Municipality of Anchorage

MEMORANDUM

SUBJECT: Response to Rabbit Creek Community Council comments on Case 2016-0151, Text Amendment to Anchorage Municipal Code, Title 21, Establishment of Base Grade and Building Design Standards on Steep Slopes.

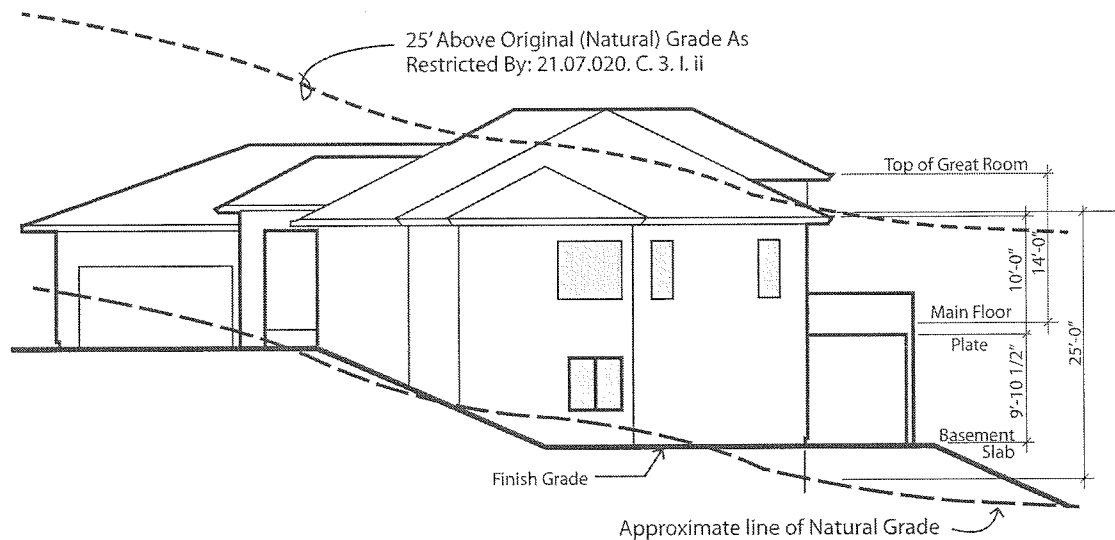
2. The maximum allowable height from the approved grade plane will be 35 feet for most of the hillside. Your concern about the potential height being 45 feet on the downslope side is justified as a result of the way that grade is measured. In fact, a home could be 4 stories tall on the downhill side. Your concern on this has also been raised by others and we modified the language of the proposed amendment to still allow 35 feet, but to restrict the height to a maximum of three stories on the downslope side.

The problem with the 25-foot height on steep slopes is that it is not measured in the same way that height is measured in any other case. That height is measured not from an established grade plane, but from the existing slope at any given point. As a result, even a ranch style home (admittedly a generous ranch-style home) with one floor and a walk-out basement has difficulty meeting the height requirement (see below).
